Re: On-Going Services  
C.F. Brown Preliminary Plat – 1<sup>st</sup> Submittal Review  
Angleton, Texas  
HDR Job No. 10391496

HDR Engineering, Inc. (HDR) has reviewed the plat for the above referenced property and offers the following comments:

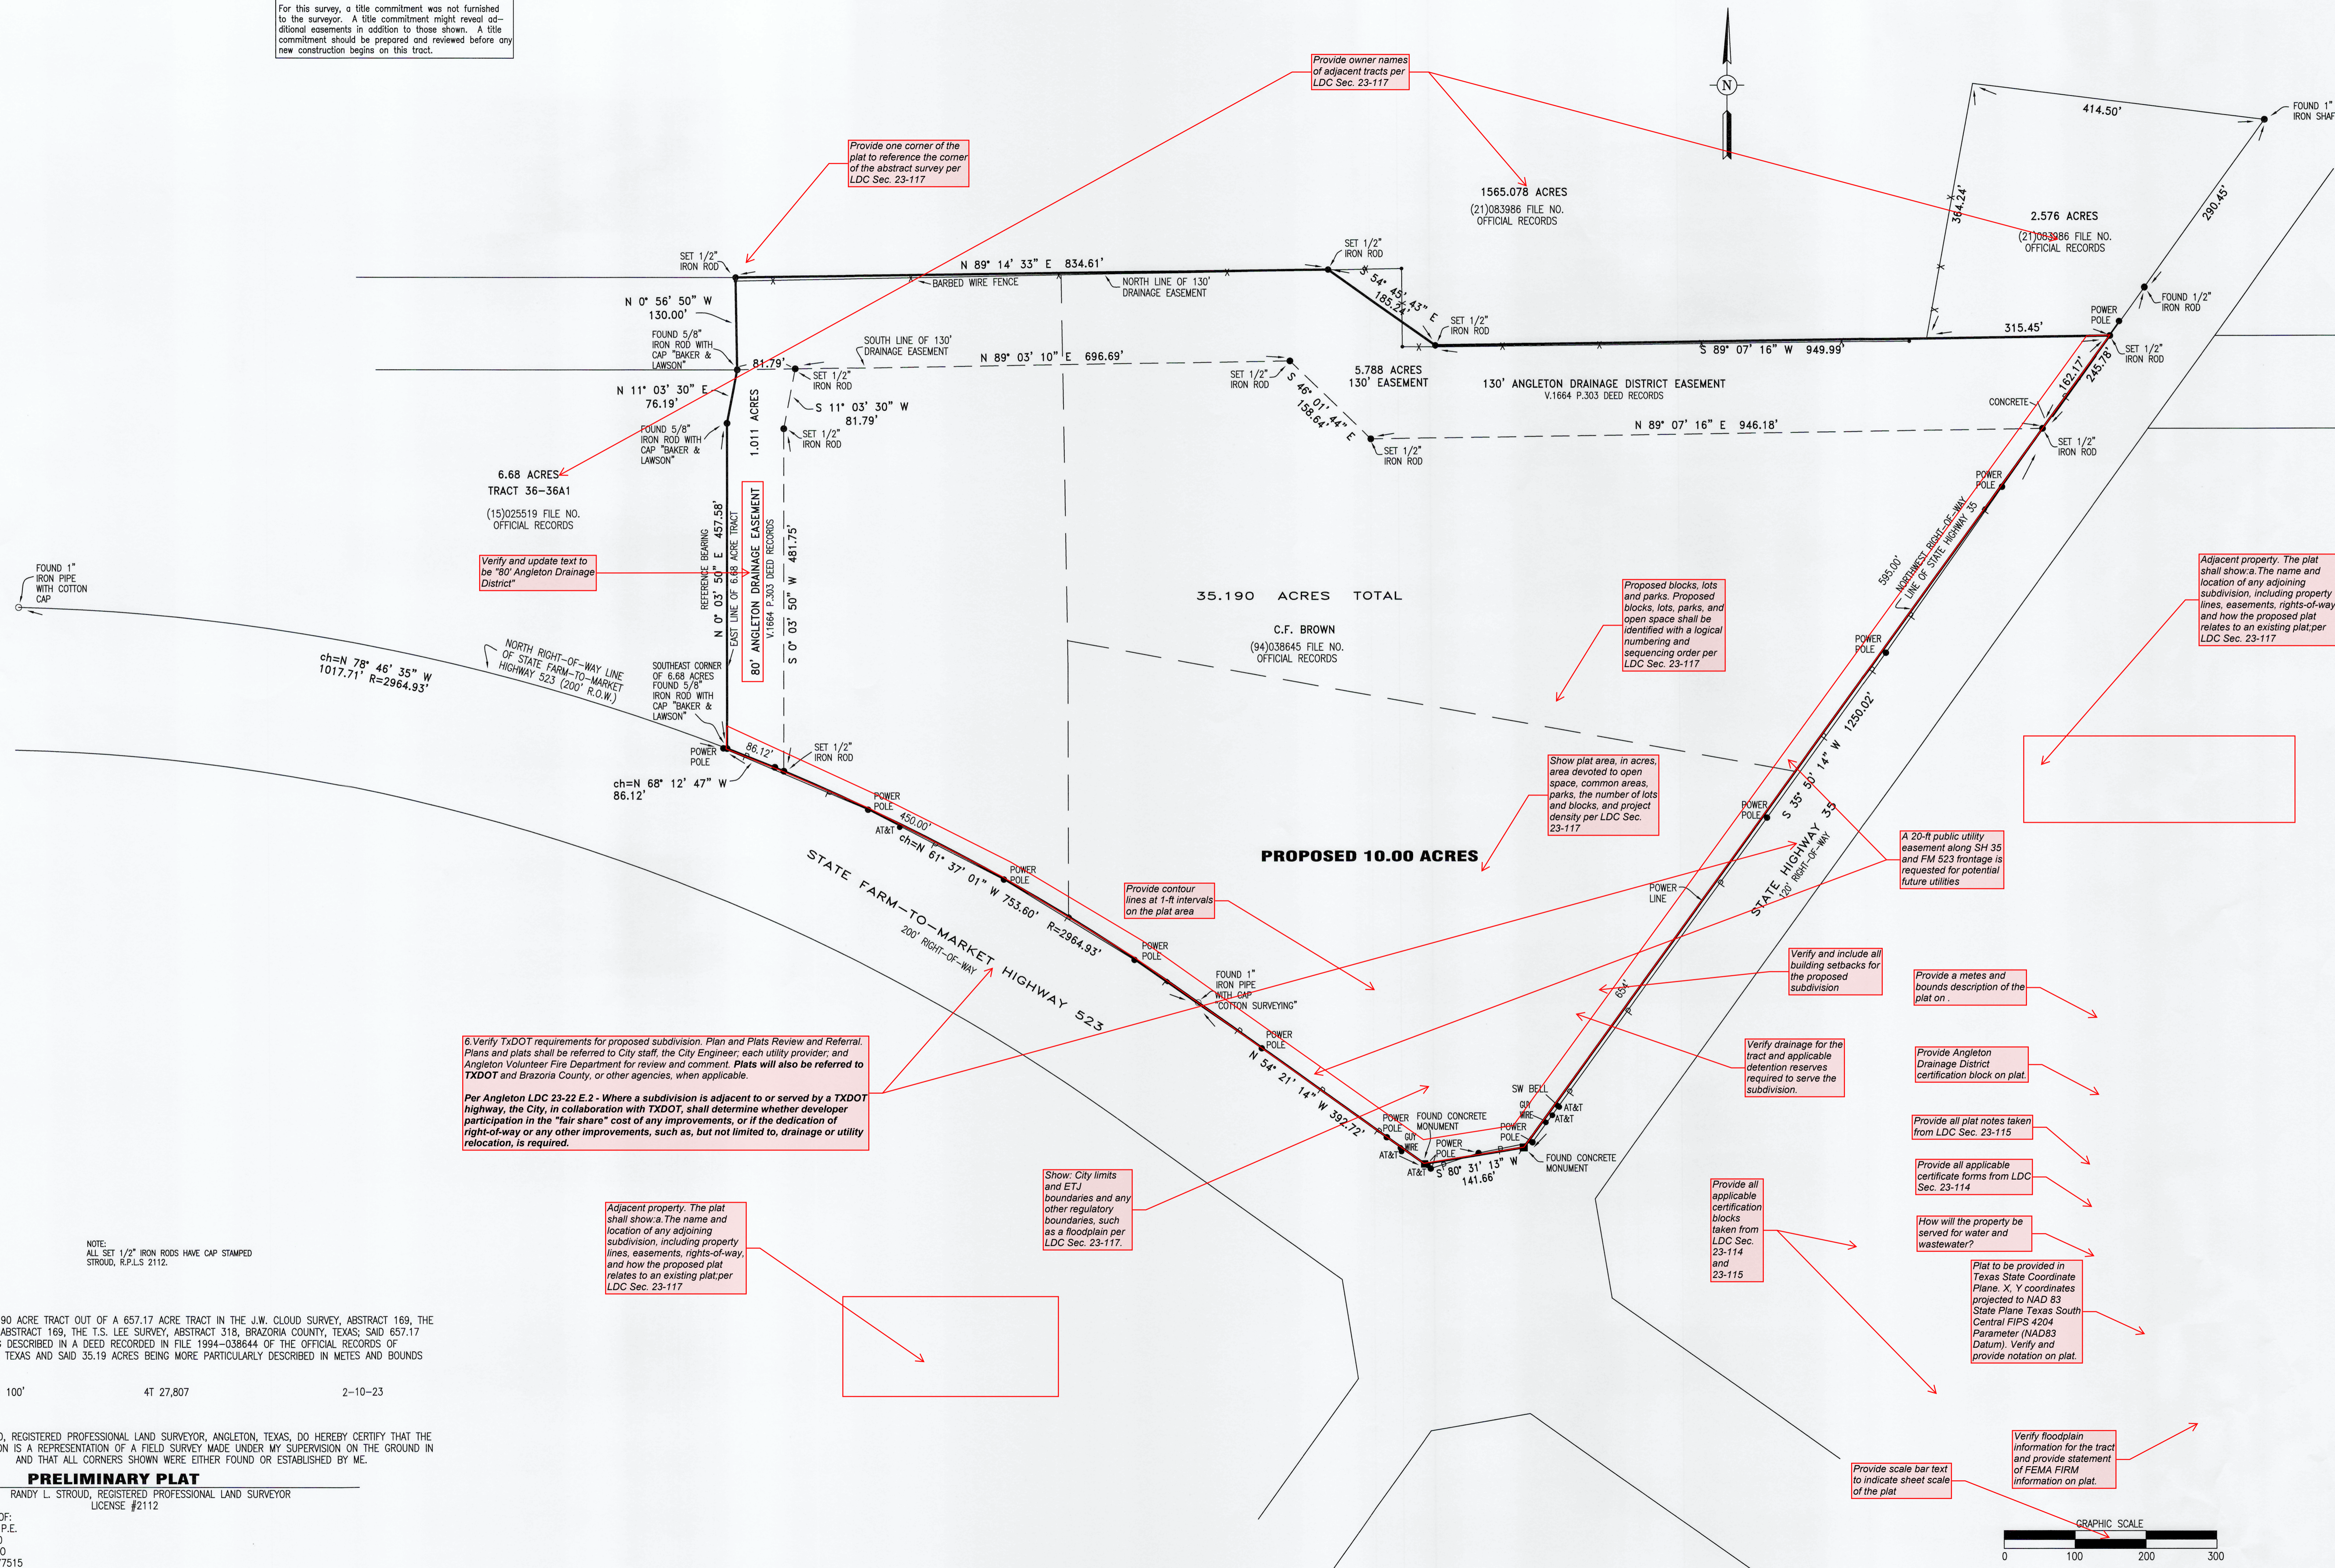
6. Verify TXDOT requirements for proposed subdivision. Plan and Plats Review and Referral. Plans and plats shall be referred to City staff, the City Engineer, each utility provider, and Angleton Volunteer Fire Department for review and comment. Plats will also be referred to TXDOT and Brazoria County, or other agencies, when applicable.  
Per Angleton LDC 23-22 E.2 - Where a subdivision is adjacent to or served by a TXDOT highway, the City, in collaboration with TXDOT, shall determine whether developer participation in the "fair share" cost of any improvements, or if the dedication of right-of-way or any other improvements, such as, but not limited to, drainage or utility relocation, is required.

Adjacent property. The plat shall show: a. The name and location of any adjoining subdivision, including property lines, easements, rights-of-way, and how the proposed plat relates to an existing plat, per LDC Sec. 23-117

Show: City limits and ETJ boundaries and any other regulatory boundaries, such as a floodplain per LDC Sec. 23-117.

Show plat area, in acres, area devoted to open space, common areas, parks, the number of lots and blocks, and project density per LDC Sec. 23-117

Proposed blocks, lots and parks. Proposed blocks, lots, parks, and open space shall be identified with a logical numbering and sequencing order per LDC Sec. 23-117

A 20-ft public utility easement along SH 35 and FM 523 frontage is requested for potential future utilities

Verify and include all building setbacks for the proposed subdivision

Provide a metes and bounds description of the plat on .

Provide Angleton Drainage District certification block on plat.

Provide all plat notes taken from LDC Sec. 23-115

Provide all applicable certificate forms from LDC Sec. 23-114

How will the property be served for water and wastewater?

Plat to be provided in Texas State Coordinate Plane. X, Y coordinates projected to NAD 83 State Plane Texas South Central FIPS 4204 Parameter (NAD83 Datum). Verify and provide notation on plat.

Verify floodplain information for the tract and provide statement of FEMA FIRM information on plat.

Provide scale bar text to indicate sheet scale of the plat
